**RE: 419 S. Pine Ave
Response to Village Comments
Haeger File No.: 24-042**

Haeger Engineering ("Haeger") is in receipt of your review comments dated April 9, 2024. We have revised the submittal materials accordingly per the comments. The original review comments are included below, shown in *italics*, with our responses to each comment followed in **bold**.

419 S. PINE AVENUE TWO-LOT SUBDIVISION SUBDIVISION IMPROVEMENT PLANS

GEOMETRY & PAVING PLAN
419 S. PINE AVENUE
TWO-LOT SUBDIVISION
 LANDMARK CUSTOM HOMES

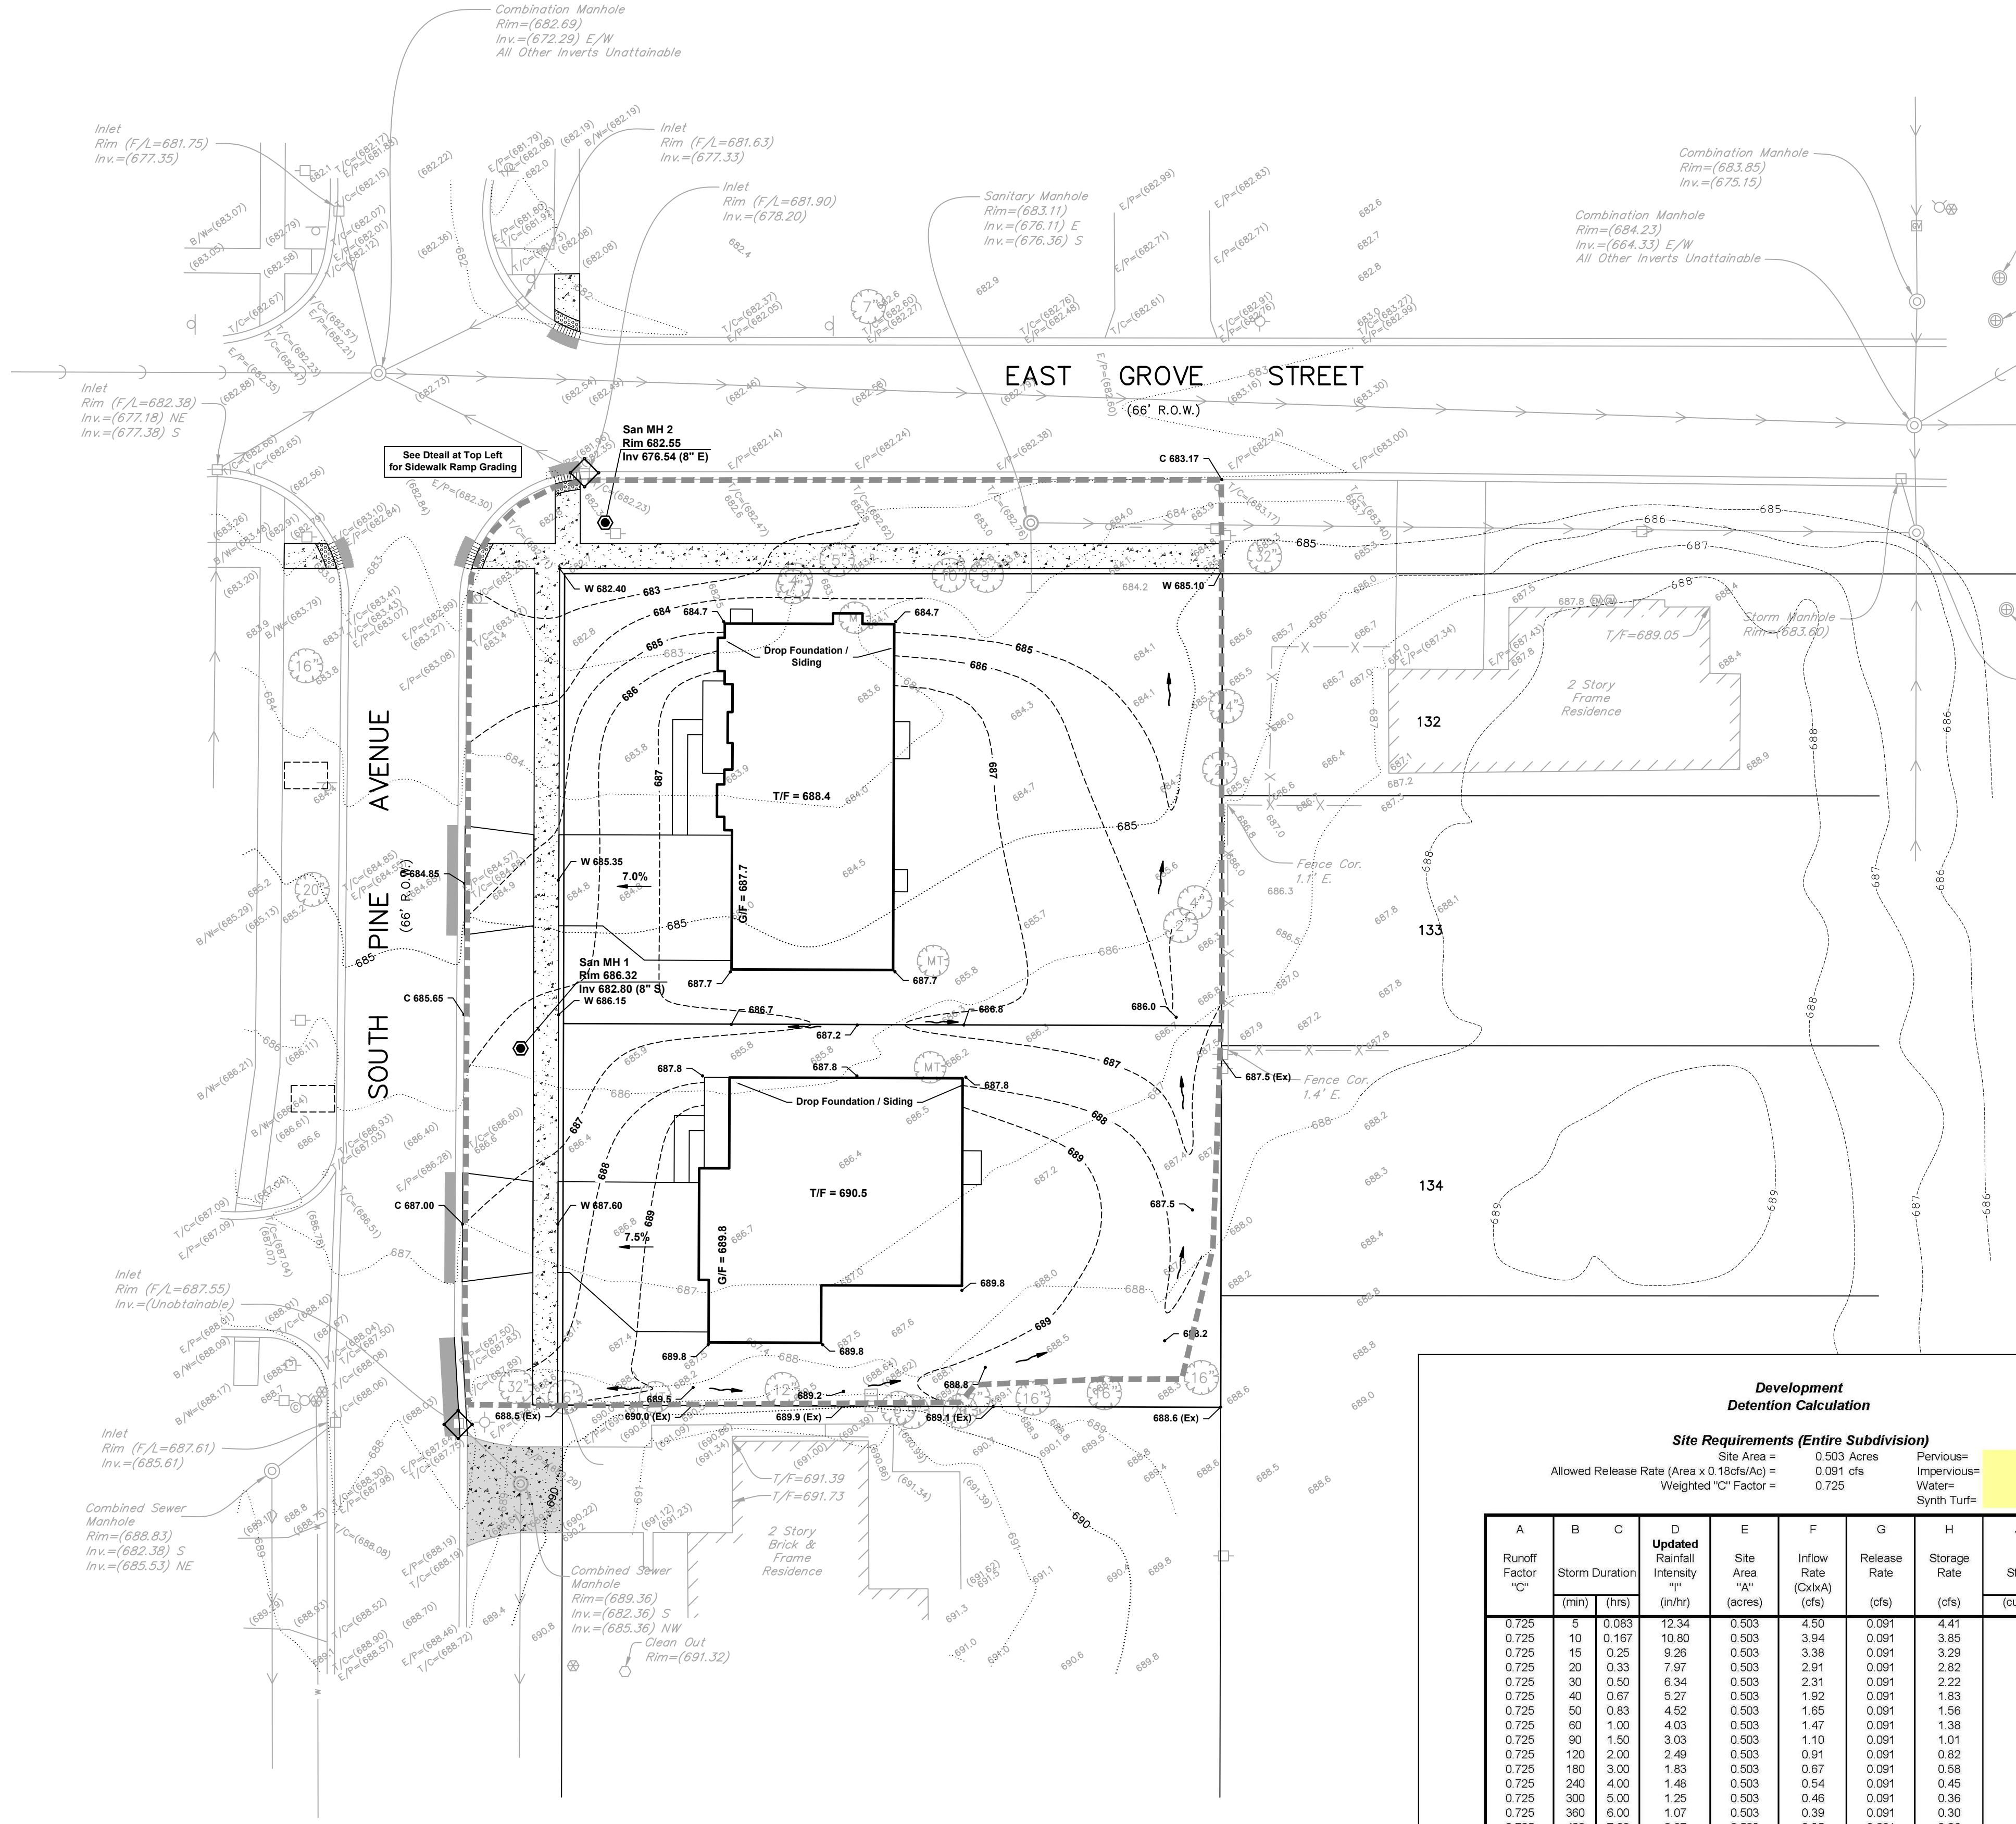
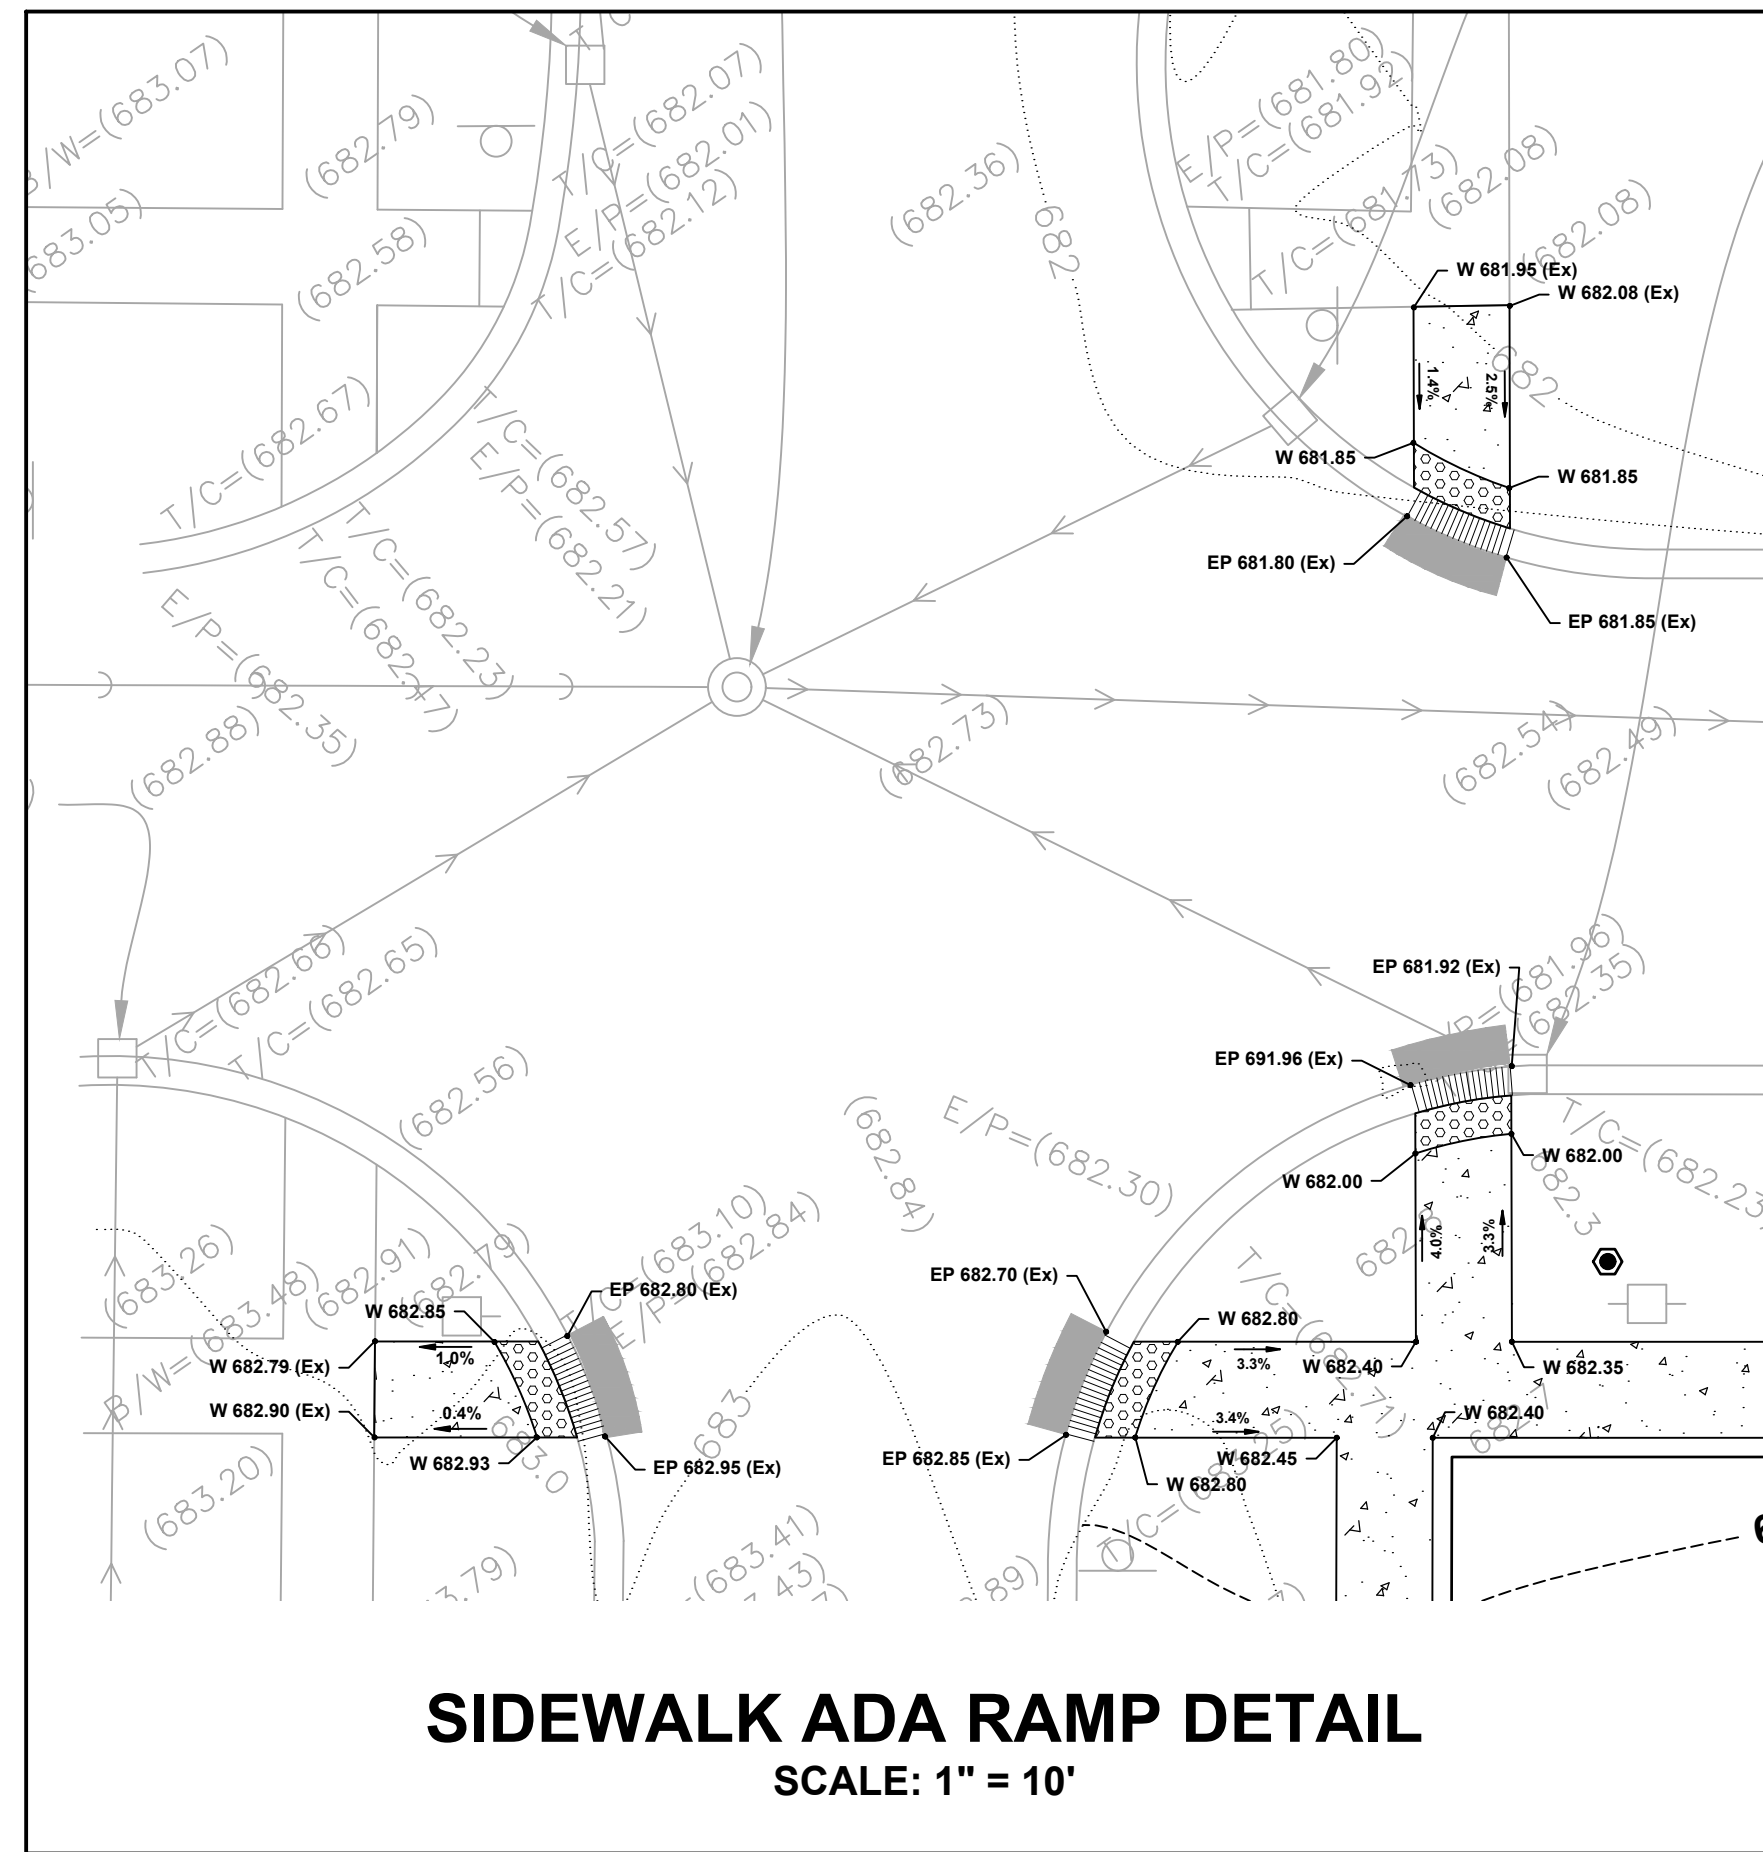
20. Correct the misalignment of curb at the south limits of the proposed subdivision.

21. Provide the curb cuts for the proposed driveway. The pavement shall be repaired adjacent to the new curb.

23. Provide ADA compliant sidewalk with depressed curb at the northeast corner of S Pine Ave and E Grove St to complete the accessible route. The southbound ramp at the NE corner shall align with the northbound ramp at the SE corner.

24. Provide ADA compliant sidewalk with depressed curb at the southwest corner of S Pine Ave and E Grove St to complete the accessible route. The eastbound ramp at the SW corner shall align with the westbound ramp at the SE corner.

This has been noted on the plans.

This has been added to the plans.

This curb ramp has been added to the plan.

This curb ramp has been added to the plan.
